NORTHEAST UTILITIES

Millstone Nuclear Power Station, Unit No. 3
Environmental and Hydrologic Engineering Branch
Responses to Draft SER Open Items

Millstone Nuclear Power Station, Unit No. 3

EHEB-01 Plant Flooding Effects of Local Intense Precipitation (Draft SER Section 2.4.2.2)

FIGURE 1

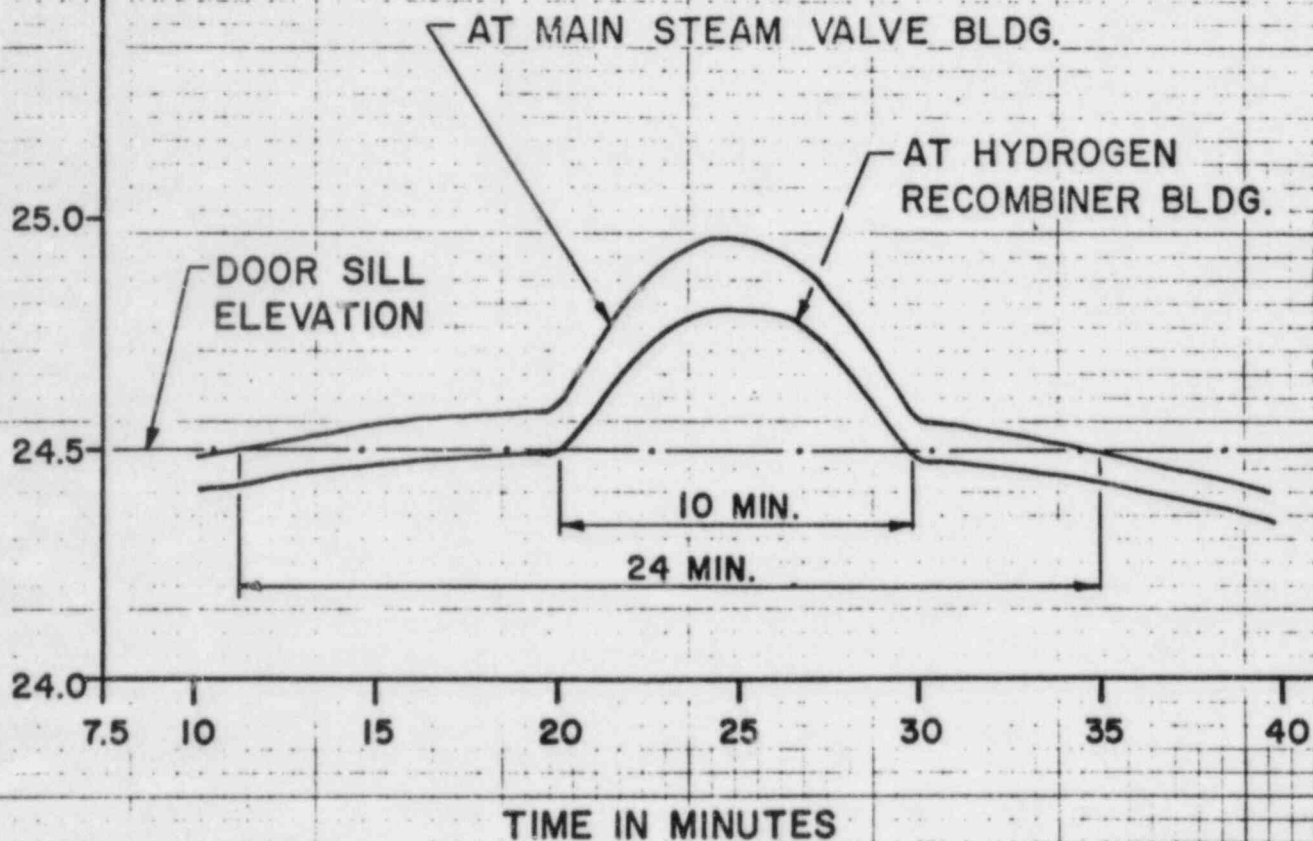
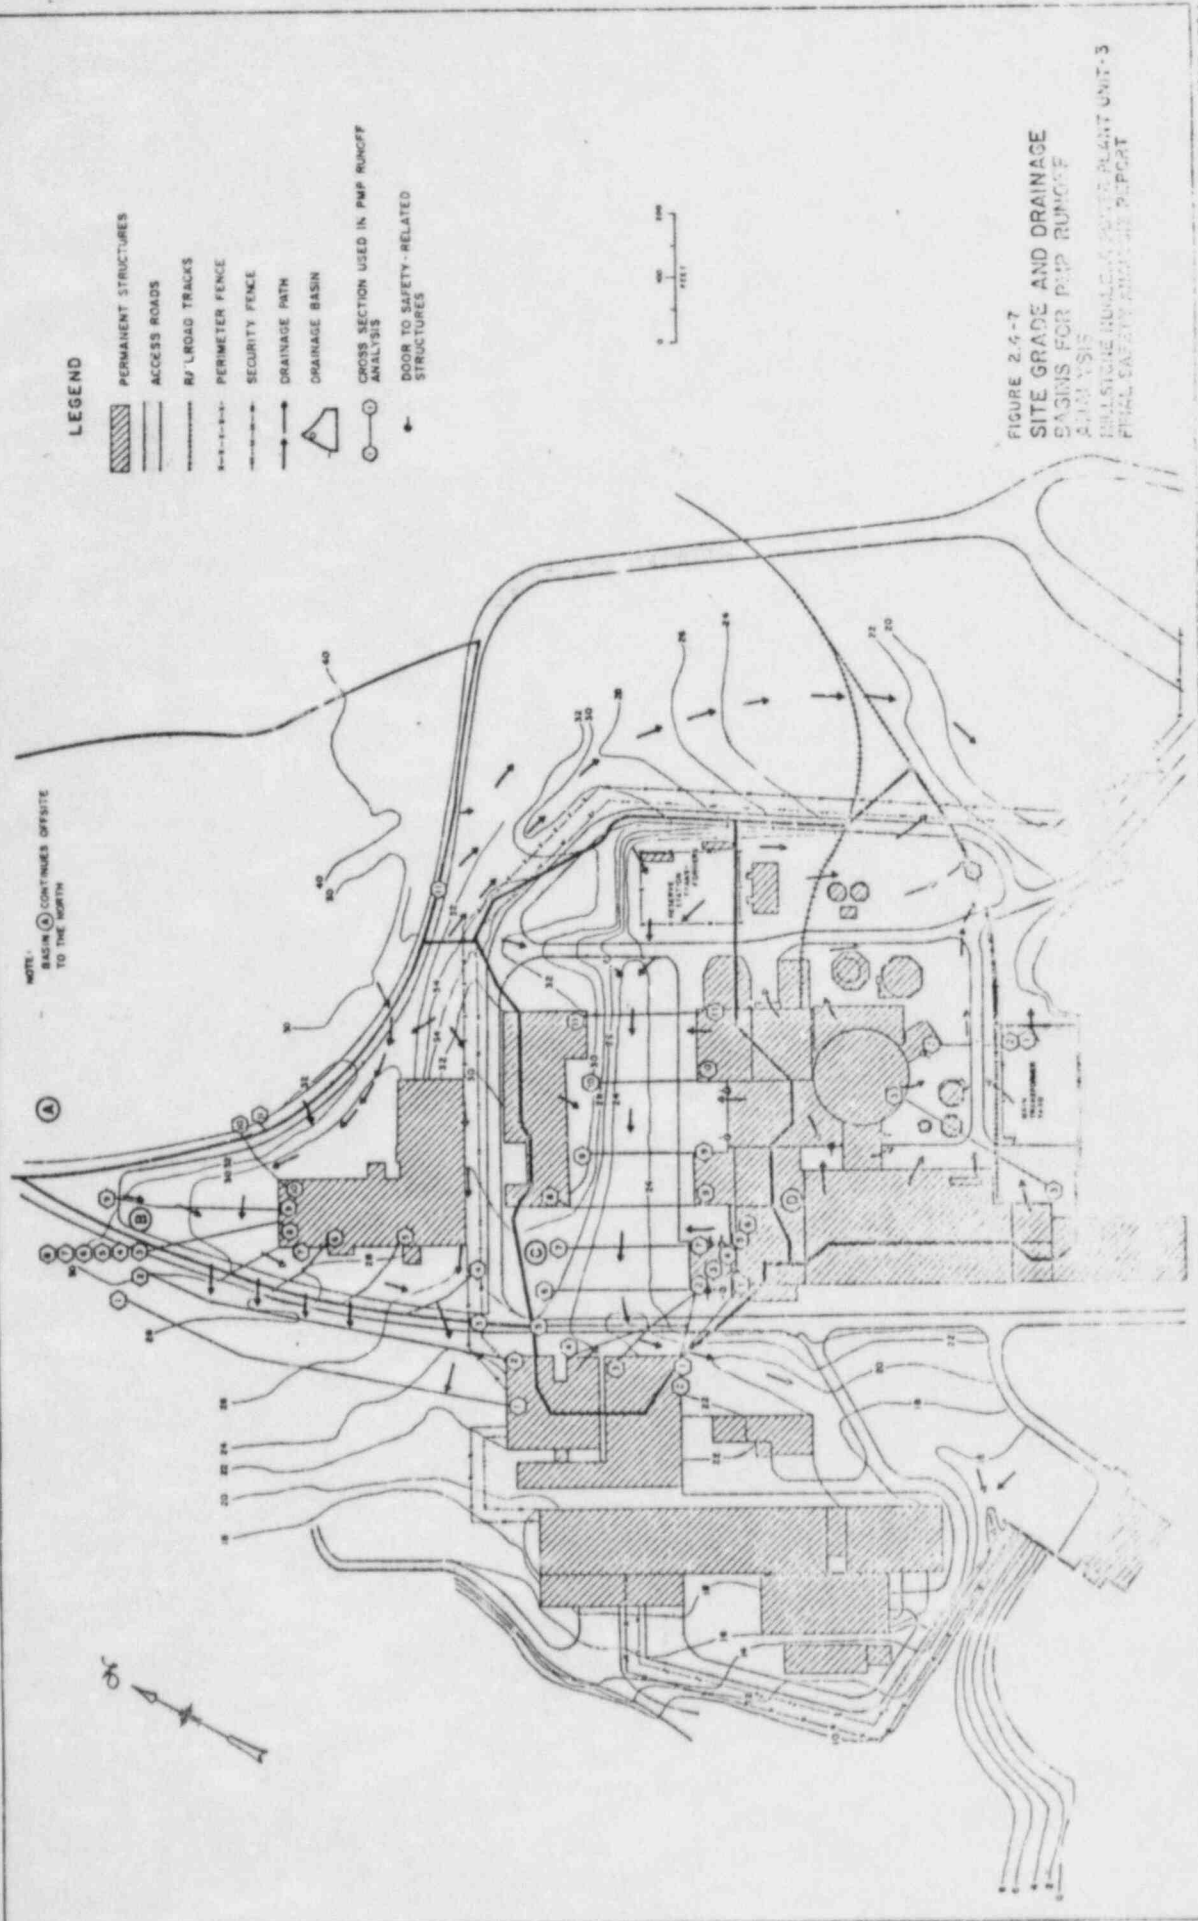
The applicant evaluated the effect of local intense precipitation of the magnitude of a PMP concentrated on the plant site, assuming complete blockage of the underground storm drainage system. The staff concluded that the site grading would limit ponding of water to a level less than el 24.5 ft MSL, which is the minimum elevation of entrances to safety-related buildings. There was, however, insufficient information available defining the drainage areas, flow patterns, and site grading (including road crown elevations and other structures that would affect flows and ponding levels) for the staff to complete its evaluation. The applicant has been asked to provide additional information and detailed analysis using the most recent PMP guidance available on rainfall depth-duration relations. Until this information and analysis are available, the staff cannot conclude that the plant meets the requirements of GDC 2 with respect to the effects of local intense precipitation runoff on site drainage relative to flooding of safety-related structures. This is an open item.

An unsteady flow analysis was performed to determine the duration of the water surface above the door sill elevation, 24.5 feet. The results of this analysis are presented in Figure 1 which is a plot of water surface elevation versus time. Using this information, a conservative analysis was performed to calculate the volume of water that would enter each structure with the door closed. The open door condition was not applicable for this analysis for the following reasons: (1) door use is controlled, (2) opening of the door is annunciated, and (3) because the doors open out, the flood water would produce a pressure differential that would resist door opening and assist in door closure. Water levels inside the structures were calculated by dividing the above computed volume by the clear floor area. The results of this analysis are summarized in Table 3.

As Table 3 shows, this flooding does not impact the safety-related equipment inside these two buildings. Note that the above analysis is conservative since no credit was taken for the floor drains which should handle 75 gpm of the water entering the structure and the critical equipment height is substantially higher than the elevation of the mounting pad that it is on.
